PR#: PR-51
FRN#: 78FR56775
NRC DOCKET#: NRC-2012-0246
SECY DOCKET DATE: 12/20/13
TITLE: Waste Confidence—Continued Storage of Spent Nuclear Fuel
COMMENT#: 00693

Re: Submission of Comments Concerning
Draft Waste Confidence Generic Environmental Impact Statement
and Proposed Rule
Docket No. NRC-2012-0246

Site-Specific Impacts Related to On-Site
Storage of Spent Nuclear Fuel at the
Indian Point Facilities, Westchester
County, NY

Figure: Effect of Storage Rack Configuration on Heatup of PWR Spent Fuel, Well-Ventilated Room. Source: 1979 Sandia Report at 51.

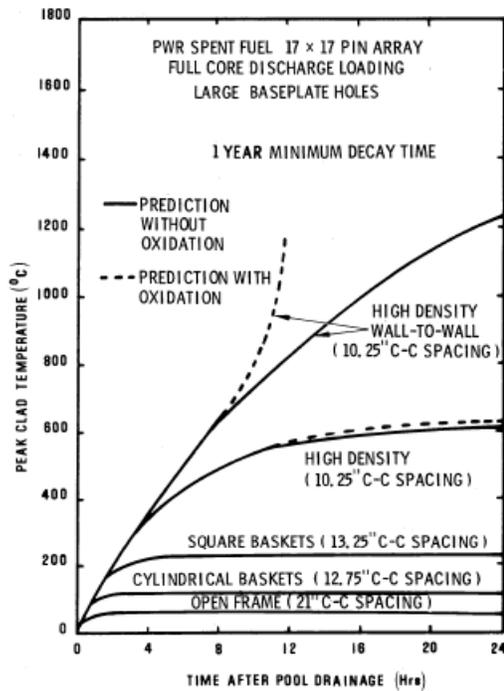
release.”¹³⁹ Therefore, NRC must consider alternatives to the current storage scheme that reduce the risk of a zirconium fire. Moreover, these issues must be considered on a site-specific Category 2 basis, since plant-specific factors may make facilities more or less vulnerable to such fires, may require different mitigative measures, and may lead to different environmental impacts.¹⁴⁰ The State recommends that the following alternatives be considered in a site-specific review of a facility’s spent fuel pool.

Figure 7: Open and dense-pack PWR spent-fuel racks (Sources: Left: NUREG/CR-0649, SAND77-1371, 1979; right: authors).

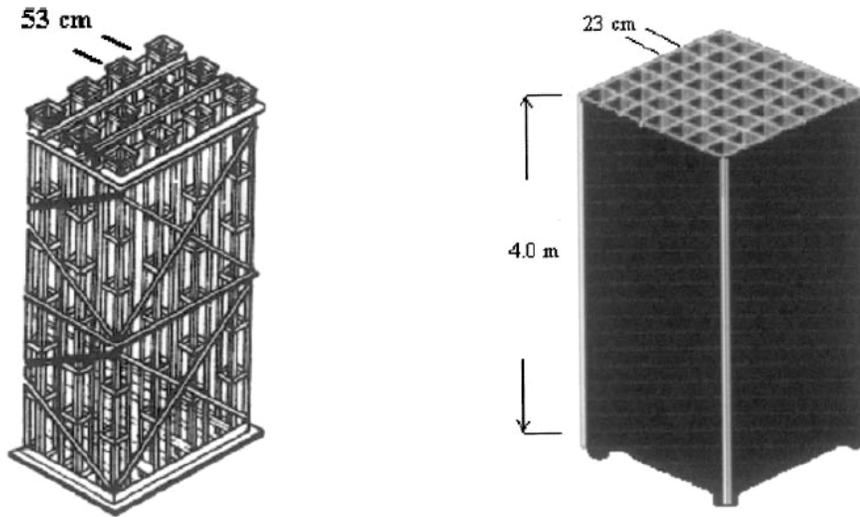
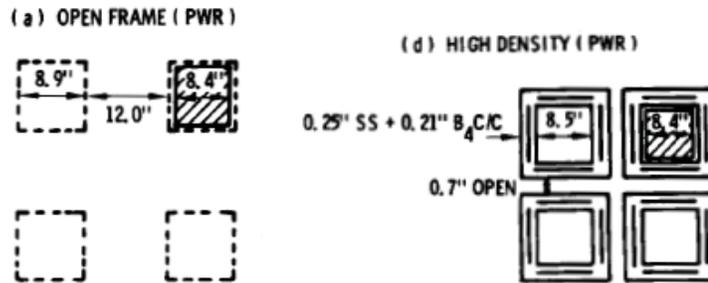
Alvarez et al. recommend moving away from the current “dense-pack” configurations and returning to open-rack configurations, for which the spent fuel pools were originally designed.¹⁴³ The figures below illustrate the different designs.¹⁴⁴

Figure 2: Removal of one fifth of the spent-fuel assemblies could result in every fuel assembly having one side exposed to an empty channel.

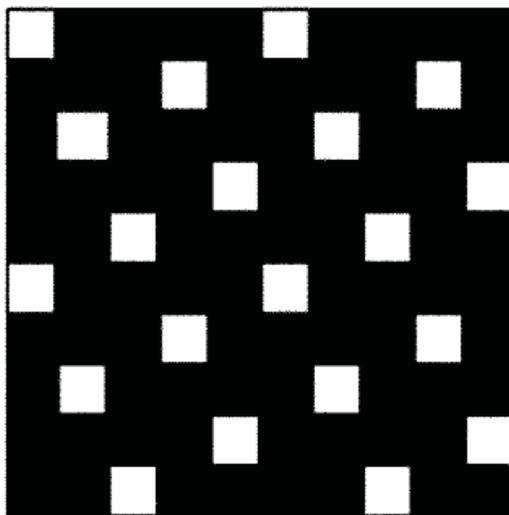
If this suggestion is found to be effective at allowing spent fuel in a drained pool to be convectively air cooled, it would reduce the amount of spent fuel that would need to be removed from pools in the U.S. in 2010 from 35,000 tons (under an open frame storage plan) to 9,000 tons.¹⁵⁵ However, Alvarez et al. recommend that all spent fuel be removed from pools and placed in dry cask storage after it has cooled for five years.

Figure 2: Population and wind rose for the Indian Point site. LEFT - Population by grid element (darker colors represent higher population) (ML13073A555 at p. 2-7), RIGHT – Wind rose for years 1999-2002 (ML12334A743).

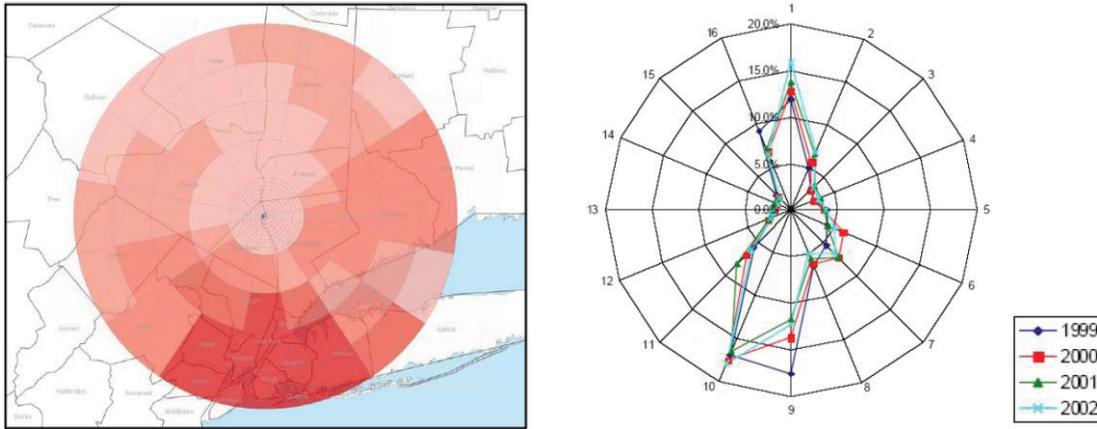
The wind rose (i.e., probability of wind directions) of the site has a direct correlation to the probability of certain areas being contaminated in the event of a severe accident and thus requiring mitigative actions. In the Consequence Study, the reference plant Peach Bottom's wind rose was such that the predominant wind directions were towards lower population areas (US-NRC 2013b, Section A.2). By comparison, the predominant wind directions at the Indian Point site are to the North/North-Northwest and to the South; the latter would affect the New York City metropolitan area, one of the most populated areas in the U.S (see Figure 2 below, showing the highest population concentrations surrounding Indian Point and the wind rose).

Figure 3: Comparison of population densities

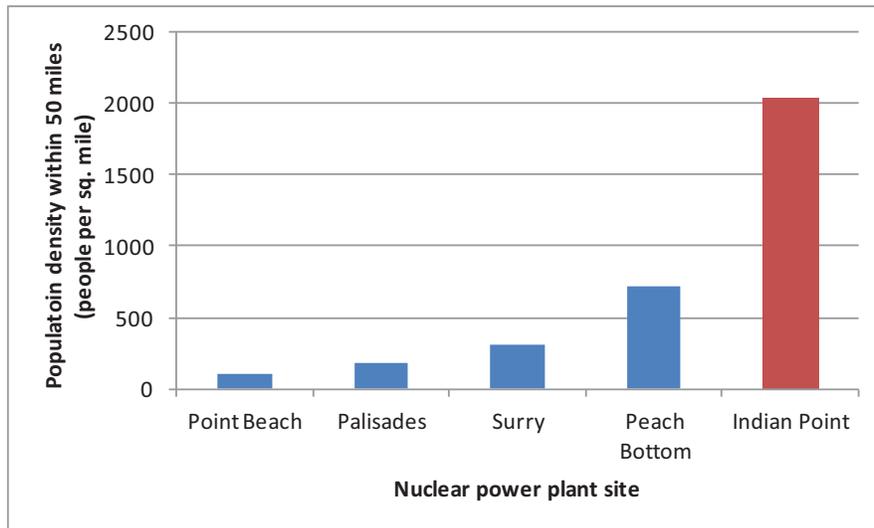
Because many plants are located in low population areas, Peach Bottom’s population may be representative of some plants. Given the combination of Indian Point’s population and predominate wind direction, the results of US-NRC’s Peach Bottom analysis are not applicable to Indian Point. As shown in Figure 3 below, the population density within 50 miles of the Indian Point site is far greater than even those considered in the Consequence Study’s sensitivity analysis.⁷ With the combination of higher population and a dominant wind direction toward the most populated areas, it is reasonable to expect that the consequences to the public surrounding Indian Point may
